Application No.	Applicant(s)	_
Notice of Allowability	10/829,176	LANG ET AL.	
	Examiner	Art Unit	_
	Zachary C. Tucker	1624	
The MAILING DATE of this communication apperature All claims being allowable, PROSECUTION ON THE MERITS IS herewith (or previously mailed), a Notice of Allowance (PTOL-85) NOTICE OF ALLOWABILITY IS NOT A GRANT OF PATENT R of the Office or upon petition by the applicant. See 37 CFR 1.313	(OR REMAINS) CLOSED in or other appropriate commu IGHTS . This application is s	this application. If not included unication will be mailed in due course. THIS	'e

Application/Control Number: 10/829,176

Response to Amendment

FIGURE 1

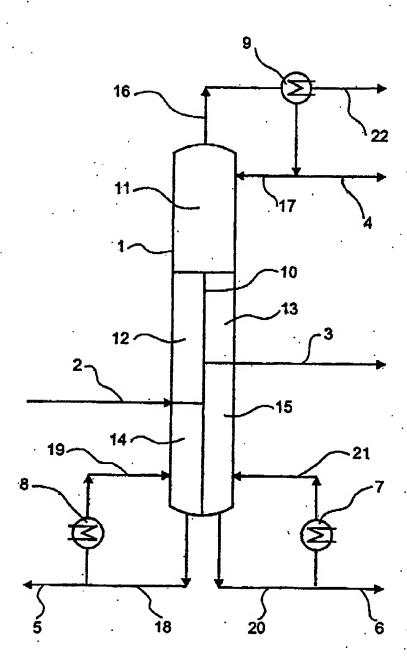
In the previous Office action, the single figure was objected to for lack of a notation "Figure 1." The objection is hereby withdrawn in view of he amended drawing.
